Fargo VAMC – Refurbish Elevators and Replace Controls

Fargo, North Dakota
Project #19-2481

MARCH 26, 2024

ADDENDUM NO. 2

A5.21

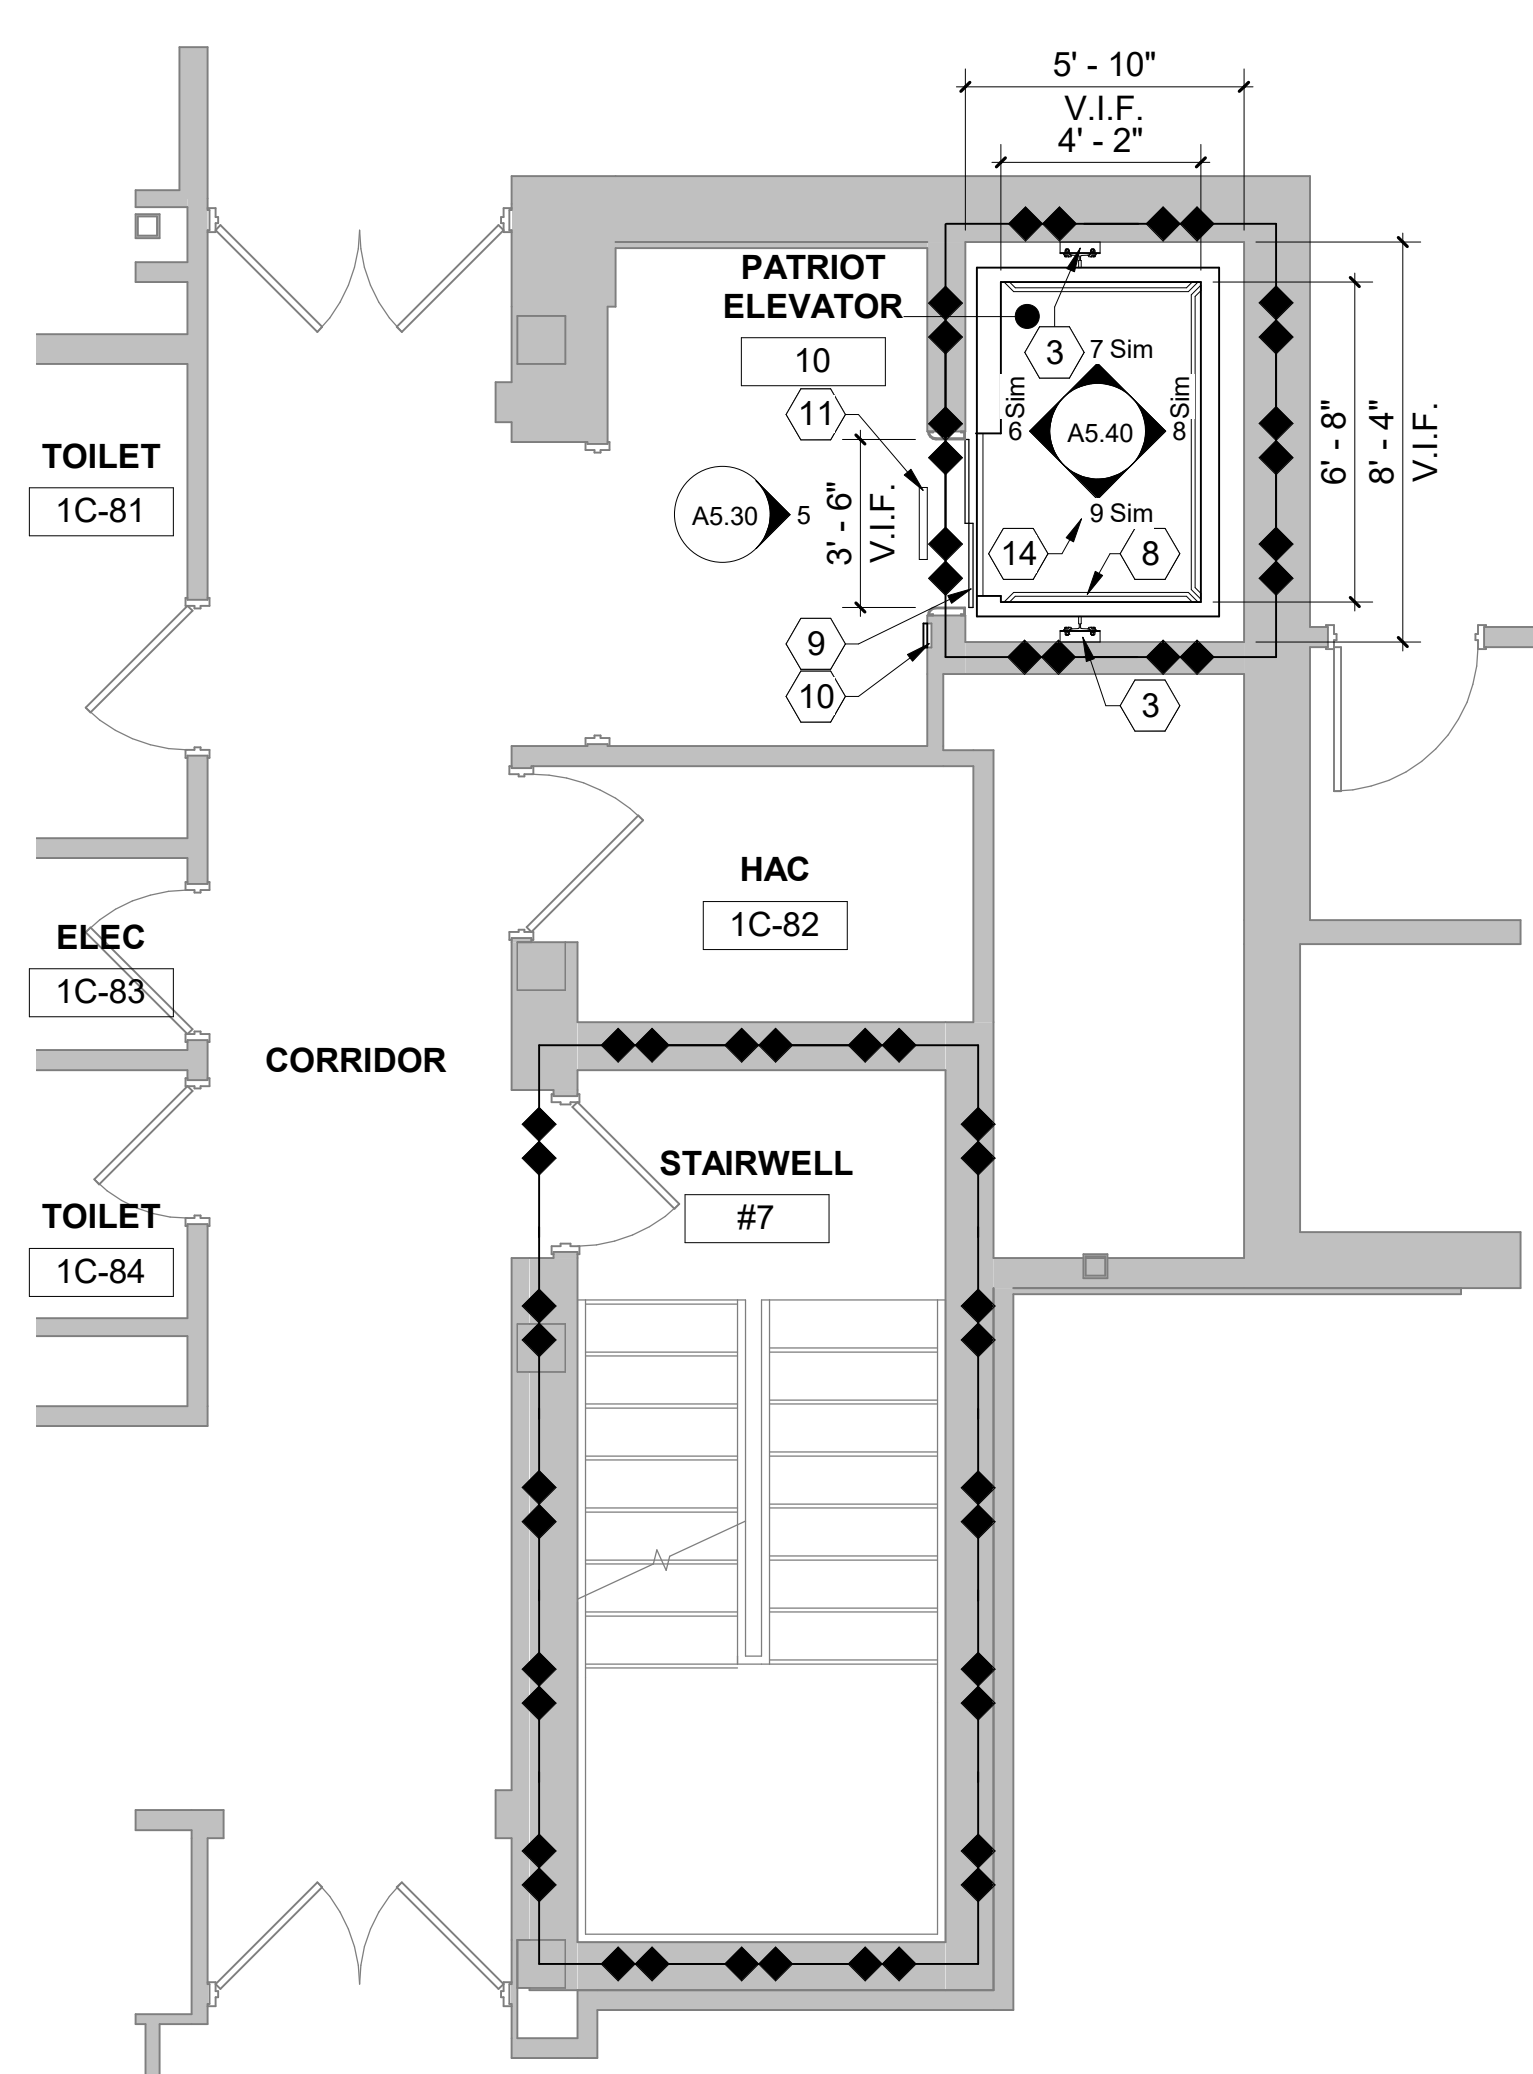
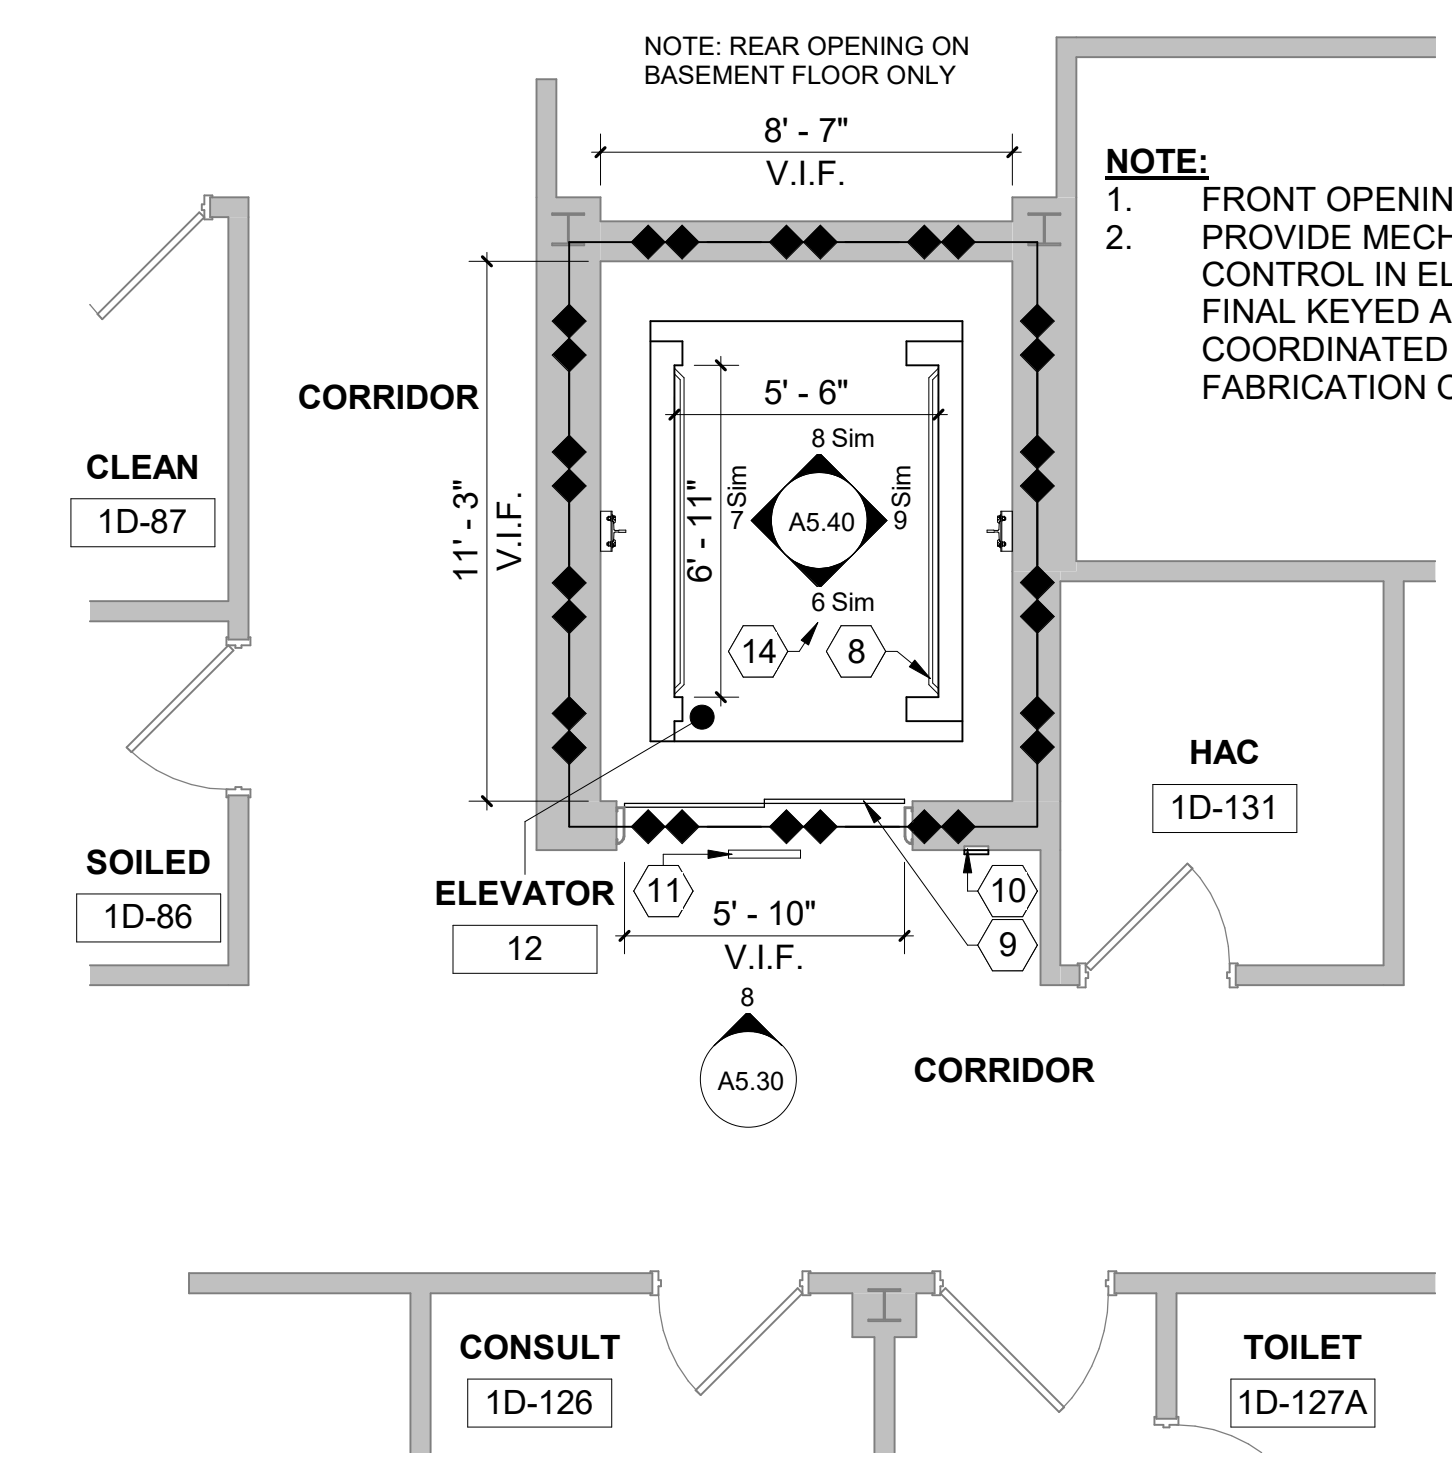
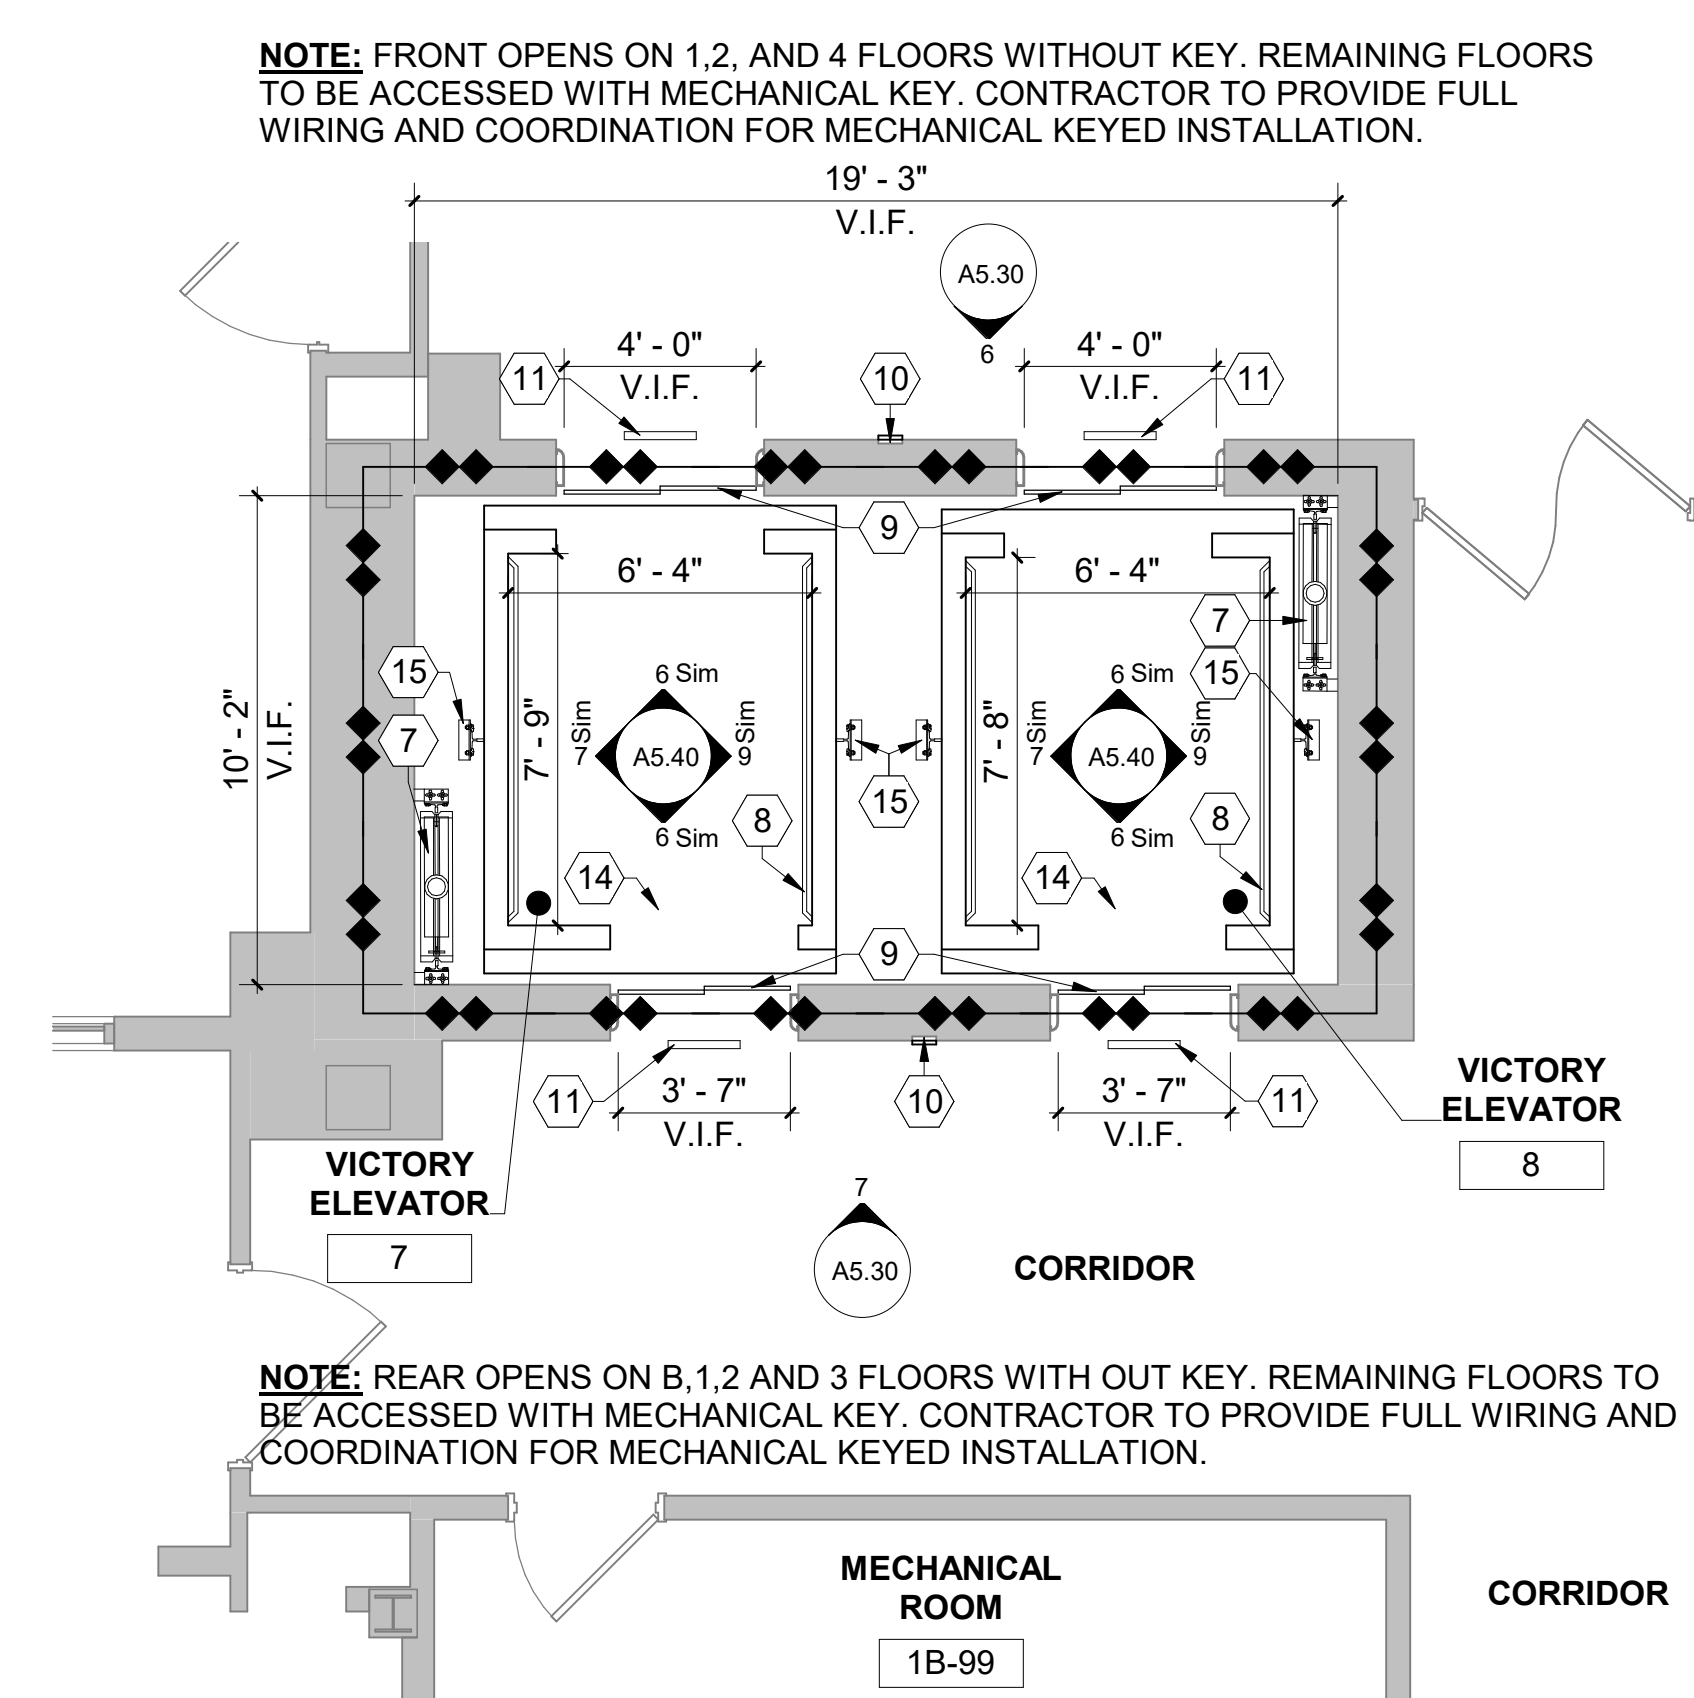
Drawing Sheet A5.21 ENLARGED PLANS – See revised drawing sheet for the adjustment of keynotes # 3, 9, 15.

- NOT USED.
- RESILIENT TILE FLOORING. SEE SPECIFICATIONS.
- REPLACE EXISTING LOWER SECTION OF GUIDE RAILS (APPROX 20 LF AT EACH RAIL) DUE TO WATER DAMAGE. APPLIES TO ELEVATOR 7 & 8 ONLY.
